ADDENDUM NO.: THREE

DATE OF ADDENDUM: April 4, 2014

**JOYNER HALL
NORTHWESTERN CONNECTICUT COMMUNITY COLLEGE
WINSTED, CT
BI – CT – 427**

GAS METER PAD DETAIL (PLAN VIEW)

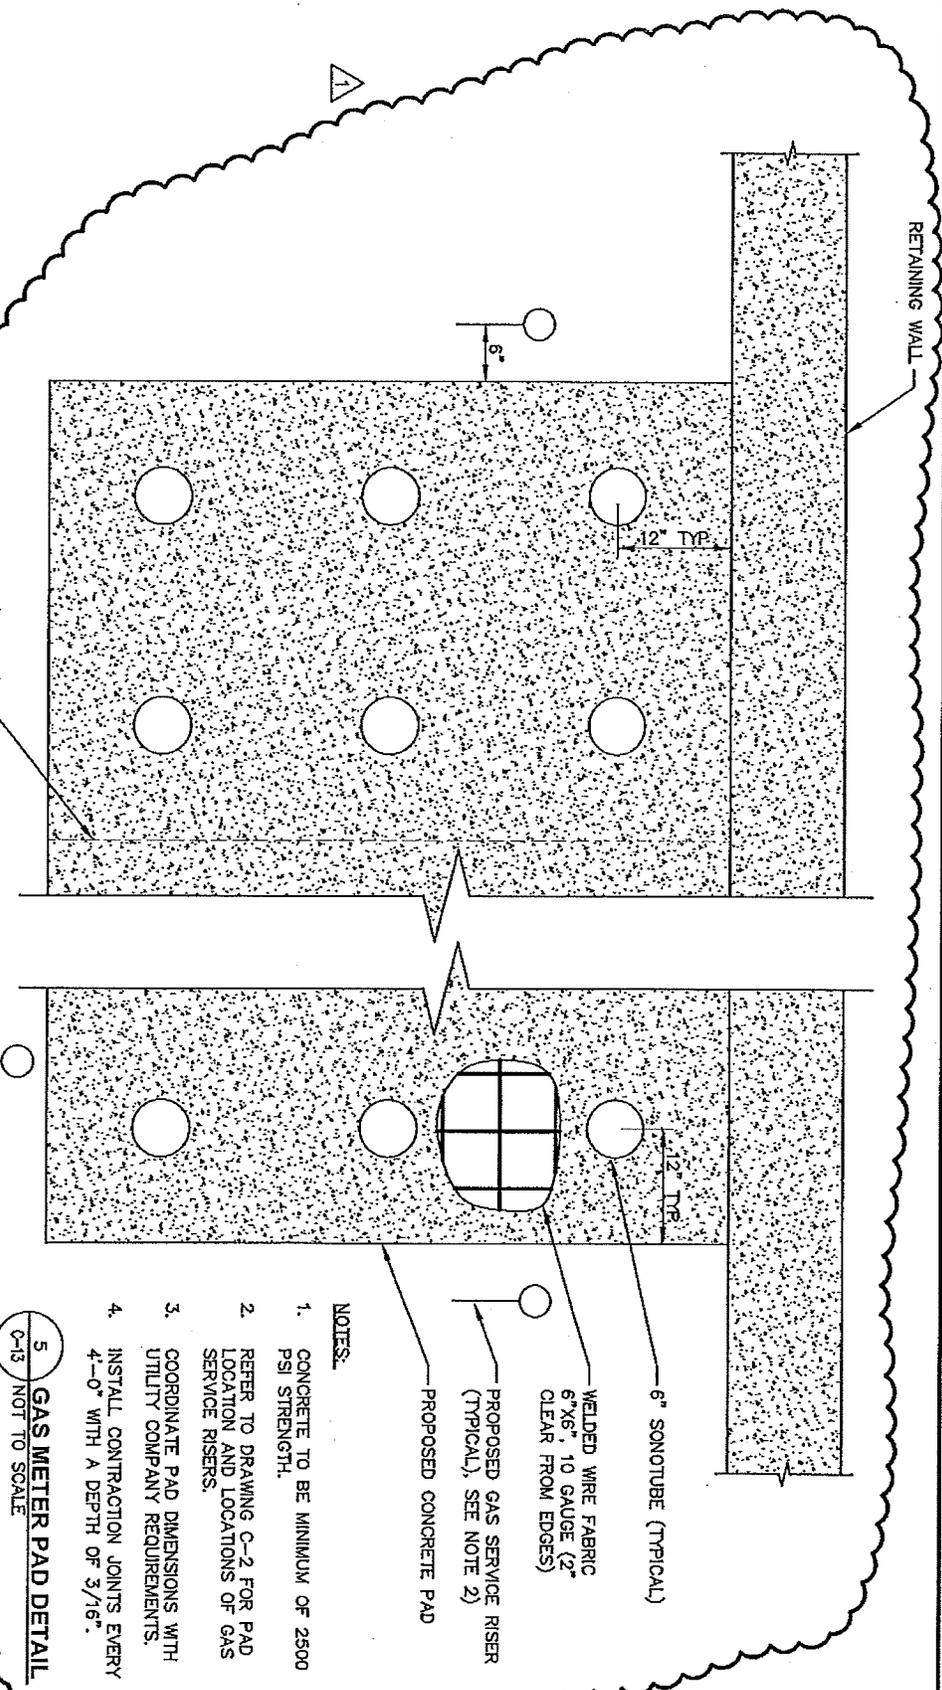
Clarification: Sketch shows plan view only of the gas meter pad detail. Refer to sketch ADC-07 attached to this addendum.

1 GAS METER PAD DETAIL (PROFILE VIEW)

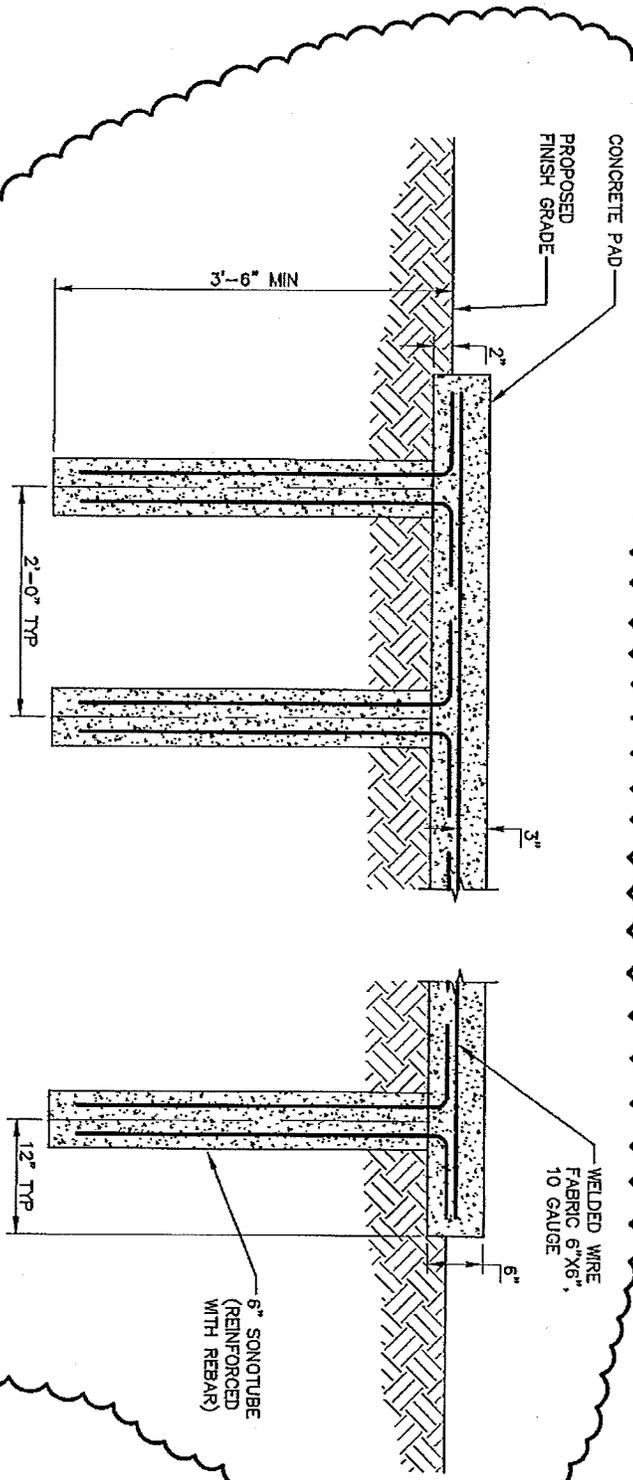
Clarification: Sketch shows profile view only of the gas meter pad detail. Refer to sketch ADC-08 attached to this addendum.
